Access Compliance Report Public Rights-of-Way (RR Crossings)

Intersection ID: 5600	Main Street: N_TRYON_ST	Location: N/A
ADA ID: DAC75988813F	Overall Compliance: No	Severity Score: 0.0
Codes/Mitigation Info/Possible Solution		Field Measurements/Component Compliance

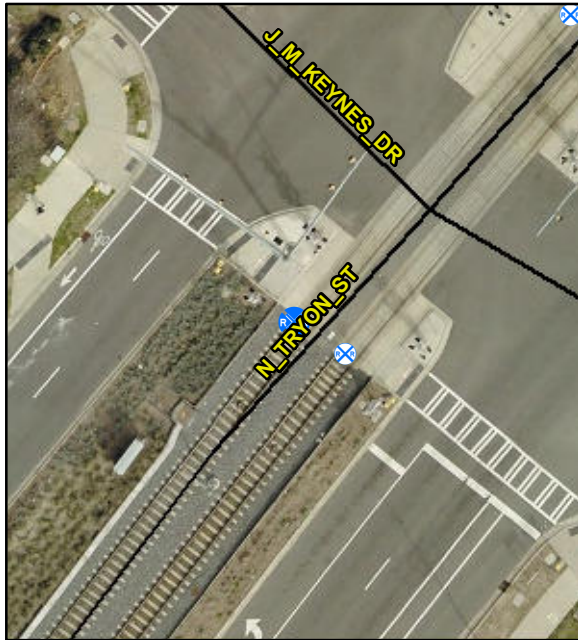
**Install Detectable Warning System.
Remove & Replace Walking Surface
Adjacent to Rail.**

R208.1, R302.7.4

Compliance	Description	Data
No	DWS Provided?	No
N/A	DWS Contrast?	N/A
N/A	DWS Width (in)	N/A
N/A	DWS Length (in)	N/A
N/A	DWS Offset (in)	190.0
Yes	Pedestrian Gate?	Yes
N/A	DWS Outside Gate?	Yes
N/A	Rail Type?	LightRail
No	Flangeway Gap (in)	2.5
Yes	Sidewalk Width (in)	116.5
